AMENDMENT OF SOLICITATION/MODIFICATION OF CONTRACT				1. CONTRACT ID CODE		PAGE OF PAGES 1   4	
2. AMENDMENT/MODIFICATION NO. 0001		3. EFFECTIVE DATE 20-May-2003		4. REQUISITION/PURCHASE REQ. NO. W68MD9-3126-3084		5. PROJECT NO.(If applicable)

14. DESCRIPTION OF AMENDMENT/MODIFICATION (Organized by UCF section headings, including solicitation/contract subject matter where feasible.) Solicitation Number: DACA67-03-Q-2010  Project Title: Parking Lot Pavement, White Bluff, Washington  See Continuation Sheet							
Except as provided herein, all terms and conditions of the document referenced in Item 9A or 10A, as heretofore changed, remains unchanged and in full force and effect.							
15A. NAME AND TITLE OF SIGNER (Type or print)				16A. NAME AND TITLE OF CONTRACTING OFFICER (Type or print) ELAINE M EBERT / CONTRACTING OFFICER TEL: (206) 764-6698 EMAIL: elaine.m.ebert@usace.army.mil			
15B. CONTRACTOR/OFFEROR  (Signature of person authorized to sign)		15C. DATE SIGNED		16B. UNITED STATES OF AMERICA  BY (Signature of Contracting Officer)		16C. DATE SIGNED 20-May-2003

1. The purpose of this amendment one (0001), dated 20 May 2003, is to incorporate the following changes.
  - a. Scop

## SECTION, TYPICAL CURB AND GUTTER

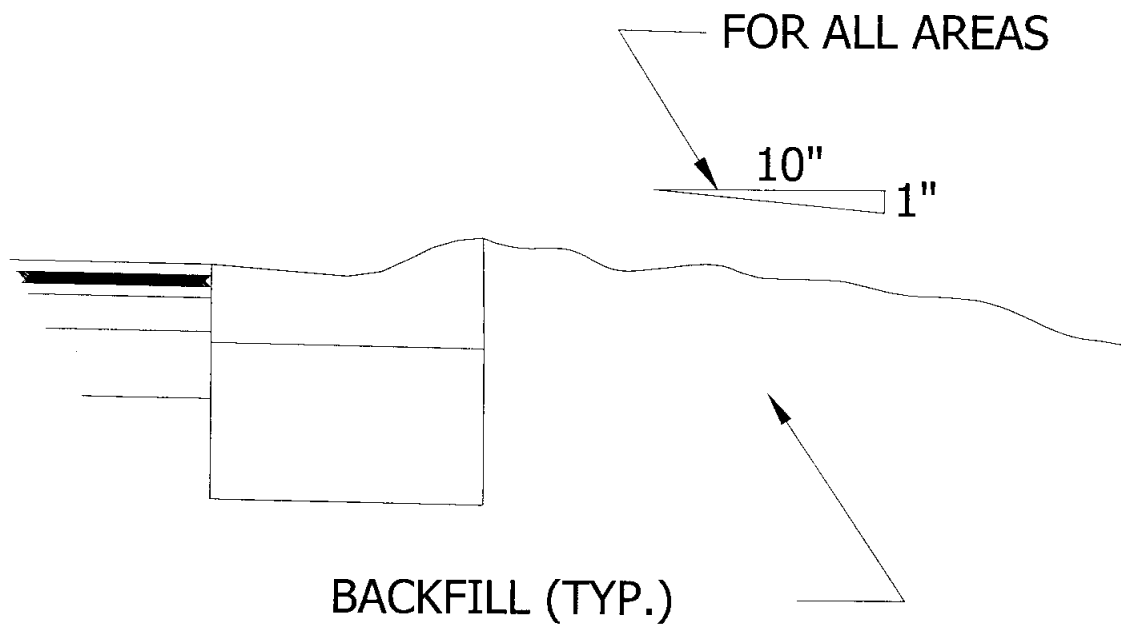
m. For the rolled concrete curb. A maximum water/cement ratio of 0.45 shall be used. The fine and course aggregate gradation shall be per ASTM C 33. The fine and course aggregate gradation shall be adjusted per ASTM C 33, paragraph 5.2 when air entrained and/or fly ash admixtures are added. The maximum size of aggregate shall be 1-1/2 inches. Concrete shall have a slump of not more than three inches. The concrete mixtures shall have air content by volume of concrete of five to seven percent, based on measurements made immediately after discharge from the mixer. Ensure the curb cut follows the dimensions in the Fairchild Design Standards found in Details 1 and 4 shown in the PDF sketches provided.
